## Product Change Notification / NTDO-22OKRR301

CCB 4931 Final Notice: Implement UKCA logo on carton label for selected BM83SM1, BMxxBLES1FC2, BMxxSPKx1MCx, BMxxSPKS1NBx, BMxxSPPSxxC2, RN467x and RN487x device families.

**CCB 4931**  
**Pre and Post Change Summary**  
**PCN #: NTDO-22OKRR301**

# Carton Label

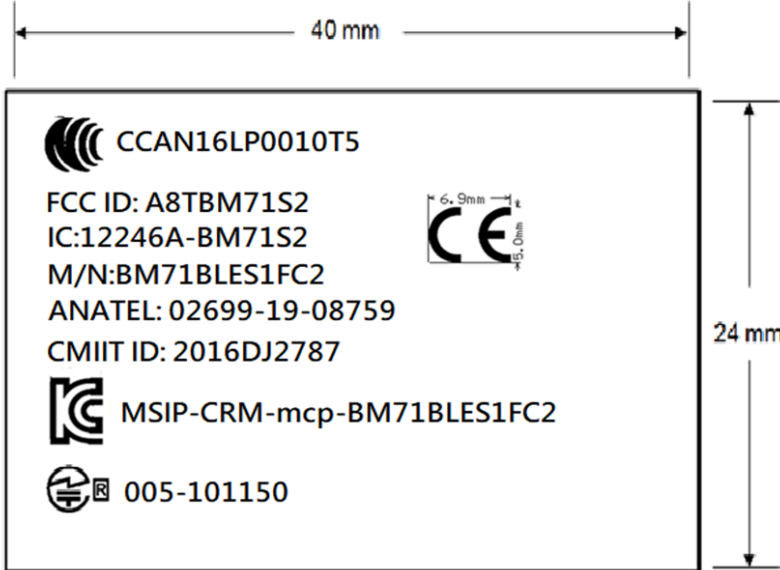
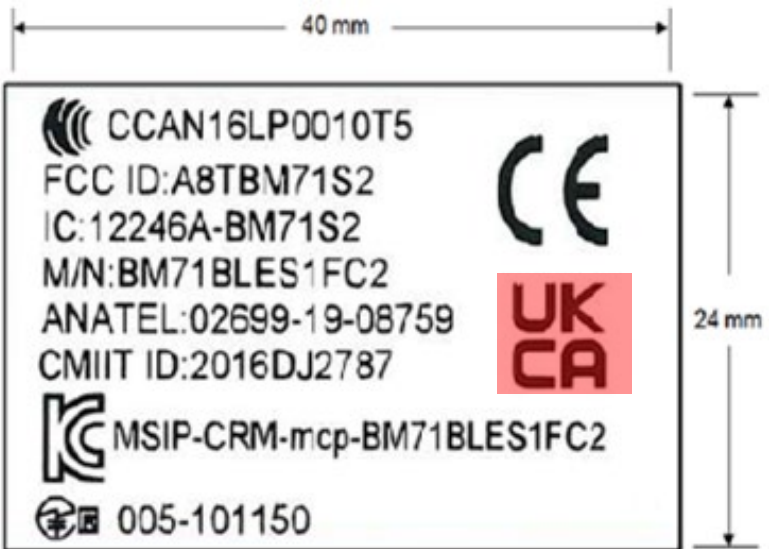
Model Name	Pre Change	Post Change	Changes
BM78SPPS5MC2	 <p>The diagram shows a rectangular label with a width of 40 mm and a height of 24 mm. On the left side, there is a logo consisting of four curved, overlapping black shapes. To the right of the logo is the text "CCAN15LP0510T4". Dimension lines indicate that the logo is 10.0 mm wide and 10.0 mm high.</p>	 <p>The diagram shows a rectangular label with a width of 40 mm and a height of 24 mm. It features the same logo and text as the pre-change label. Additionally, there is a red square logo with the letters "UK" stacked above "CA" positioned below the text "CCAN15LP0510T4". Dimension lines indicate that the logo is 10.0 mm wide and 10.0 mm high.</p>	Add UKCA logo

# Carton Label

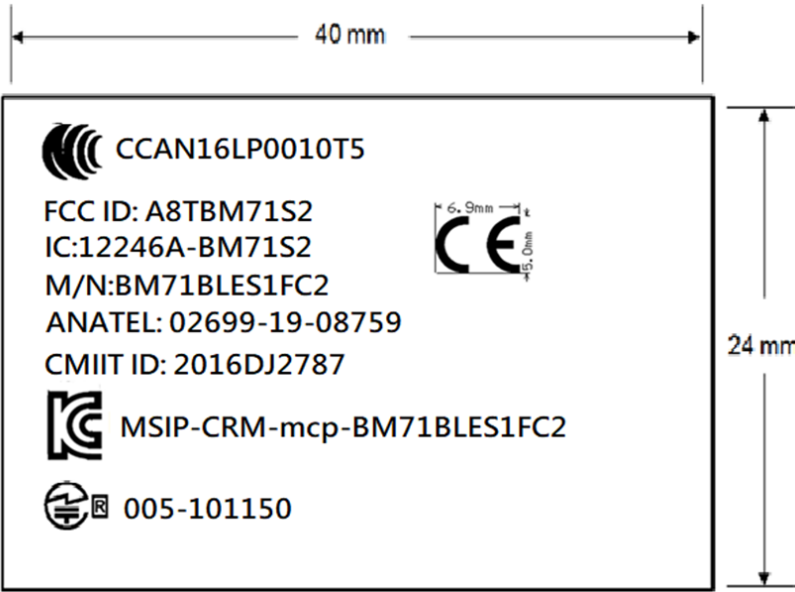
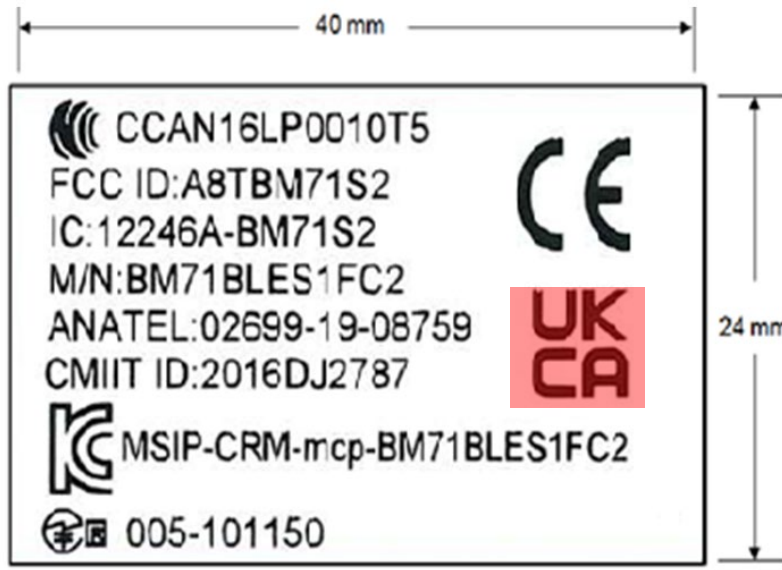
Model Name	Pre Change	Post Change	Changes
BM78SPPS5NC2	 <p>The diagram shows a rectangular label with a width of 40 mm and a height of 24 mm. On the left side, there is a logo consisting of four curved lines. To the right of the logo is the text "CCAN15LP0510T4". Dimension lines indicate that the logo is 10.0 mm wide and 10.0 mm high.</p>	 <p>The diagram shows a rectangular label with a width of 40 mm and a height of 24 mm. On the left side, there is a logo consisting of four curved lines. To the right of the logo is the text "CCAN18LP0800T1". Below the text is a red square logo with the letters "UK" stacked above "CA". Dimension lines indicate that the logo is 10.0 mm wide and 10.0 mm high.</p>	<ul style="list-style-type: none"><li>• Recertification NCC</li><li>• Add UKCA logo</li></ul>

# Carton Label

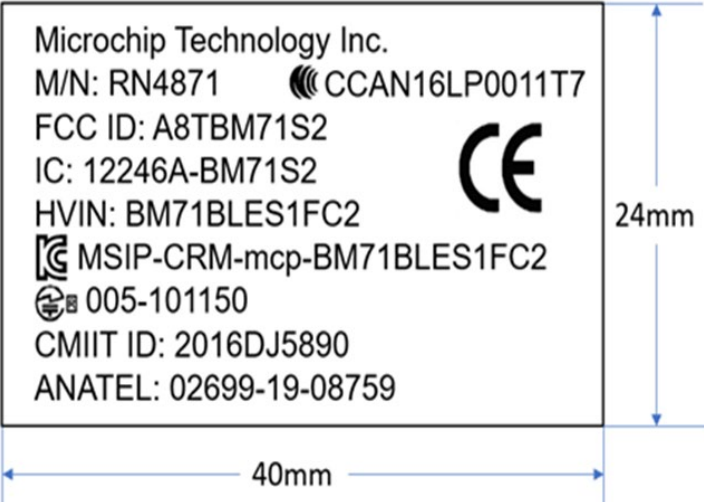
Model Name	Pre Change	Post Change	Changes
BM70BLES1FC2	 <p>Diagram of the pre-change carton label. The label is rectangular with a width of 40 mm and a height of 24 mm. It features a Microchip logo on the left, a width of 10.0 mm, and the part number CCAN15LP0510T4 to its right.</p>	 <p>Diagram of the post-change carton label. The label is rectangular with a width of 40 mm and a height of 24 mm. It features a Microchip logo on the left, a width of 10.0 mm, the part number CCAN15LP0510T1 to its right, and a red UKCA logo below the part number.</p>	<ul style="list-style-type: none"><li>• Recertification NCC</li><li>• Add UKCA logo</li></ul>

# Carton Label

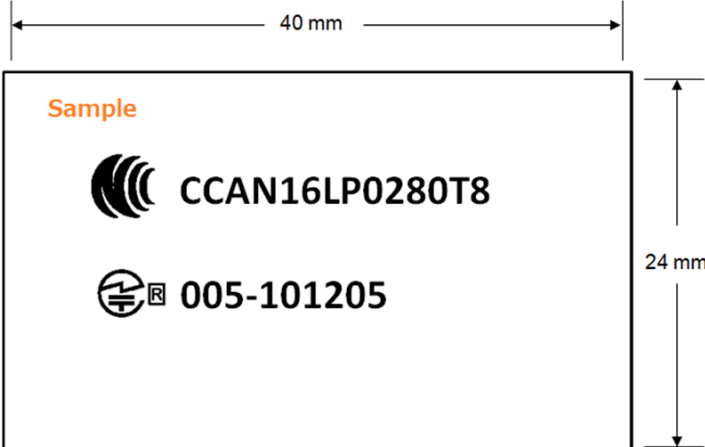
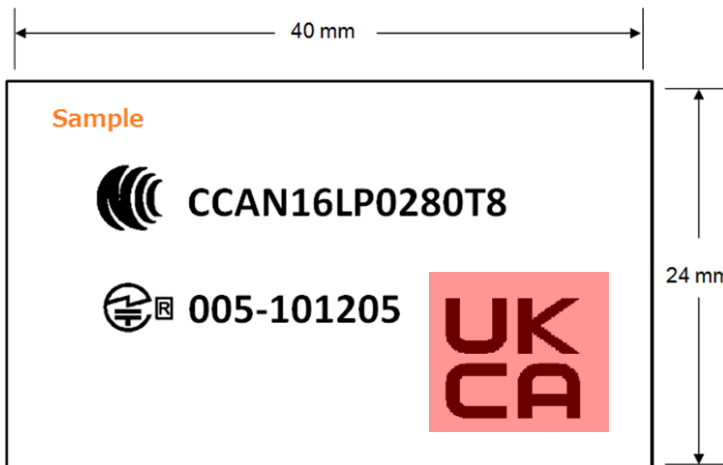
Model Name	Pre Change	Post Change	Changes
BM71BLES1FC2	 <p>Diagram of the pre-change carton label. It is a rectangle with a width of 40 mm and a height of 24 mm. The label contains the following text and logos from top to bottom: a circular logo with three curved lines and the text 'CCAN16LP0010T5'; 'FCC ID: A8TBM71S2'; 'IC:12246A-BM71S2'; 'M/N:BM71BLES1FC2'; 'ANATEL: 02699-19-08759'; 'CMIIT ID: 2016DJ2787'; a 'K' logo with 'MSIP-CRM-mcp-BM71BLES1FC2'; and a square logo with '005-101150'. A CE mark is located on the right side of the label, with a dimension line indicating its height as 6.9mm.</p>	 <p>Diagram of the post-change carton label. It is a rectangle with a width of 40 mm and a height of 24 mm. The label contains the following text and logos from top to bottom: a circular logo with three curved lines and the text 'CCAN16LP0010T5'; 'FCC ID: A8TBM71S2'; 'IC:12246A-BM71S2'; 'M/N:BM71BLES1FC2'; 'ANATEL: 02699-19-08759'; 'CMIIT ID: 2016DJ2787'; a 'K' logo with 'MSIP-CRM-mcp-BM71BLES1FC2'; and a square logo with '005-101150'. In addition to the CE mark, a red UKCA logo is added to the right side of the label.</p>	Add UKCA logo

# Carton Label

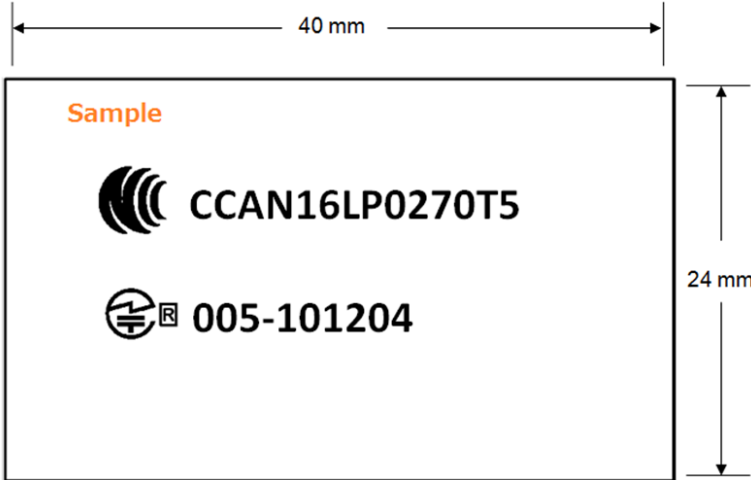
Model Name	Pre Change	Post Change	Changes
RN4871-V	 <p>Diagram of the pre-change carton label. It is a rectangle with a width of 40 mm and a height of 24 mm. The label contains the following text and logos from top to bottom: a circular logo with three curved lines, the model number CCAN16LP0010T5, FCC ID: A8TBM71S2, IC:12246A-BM71S2, M/N:BM71BLES1FC2, ANATEL: 02699-19-08759, CMIIT ID: 2016DJ2787, a square logo with a stylized 'K' and 'C', MSIP-CRM-mcp-BM71BLES1FC2, a square logo with a stylized 'E' and 'R', and 005-101150. A CE mark is located to the right of the FCC and IC information, with dimensions 6.9mm and 4.5mm indicated.</p>	 <p>Diagram of the post-change carton label. It is a rectangle with a width of 40 mm and a height of 24 mm. The label contains the following text and logos from top to bottom: a circular logo with three curved lines, the model number CCAN16LP0010T5, FCC ID: A8TBM71S2, IC:12246A-BM71S2, M/N:BM71BLES1FC2, ANATEL:02699-19-08759, CMIIT ID:2016DJ2787, a square logo with a stylized 'K' and 'C', MSIP-CRM-mcp-BM71BLES1FC2, a square logo with a stylized 'E' and 'R', and 005-101150. A large CE mark and a red UKCA logo are added to the right side of the label.</p>	Add UKCA logo

# Carton Label

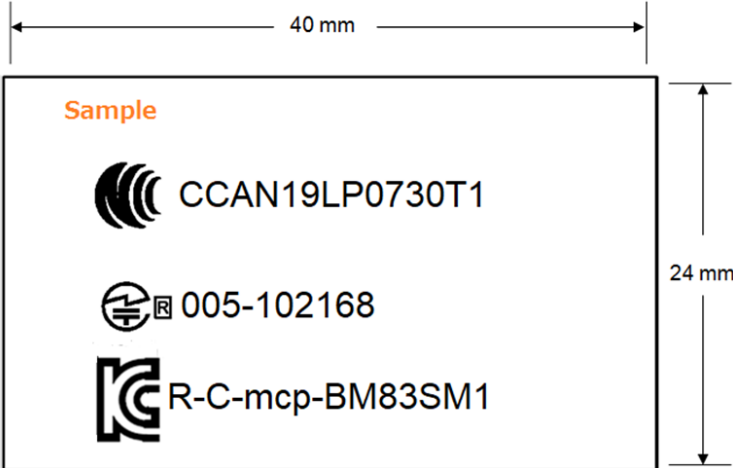
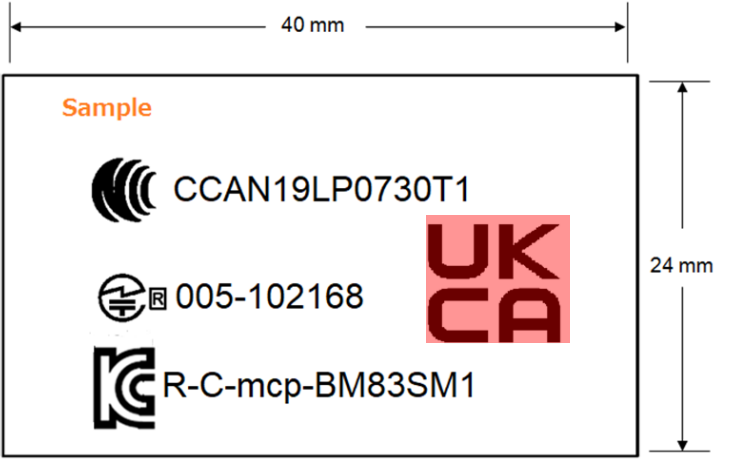
Model Name	Pre Change	Post Change	Changes
BM64SPKS1MC1	 <p>Microchip Technology Inc.  M/N: RN4871    CCAN16LP0011T7  FCC ID: A8TBM71S2  IC: 12246A-BM71S2  HVIN: BM71BLES1FC2  MSIP-CRM-mcp-BM71BLES1FC2  005-101150  CMIIT ID: 2016DJ5890  ANATEL: 02699-19-08759</p>	 <p>Microchip Technology Inc.  M/N: RN4871    CCAN16LP0011T7  FCC ID: A8TBM71S2  IC: 12246A-BM71S2  HVIN: BM71BLES1FC2  MSIP-CRM-mcp-BM71BLES1FC2  005-101150  CMIIT ID: 2016DJ5890  ANATEL: 02699-19-08759</p>	Add UKCA logo
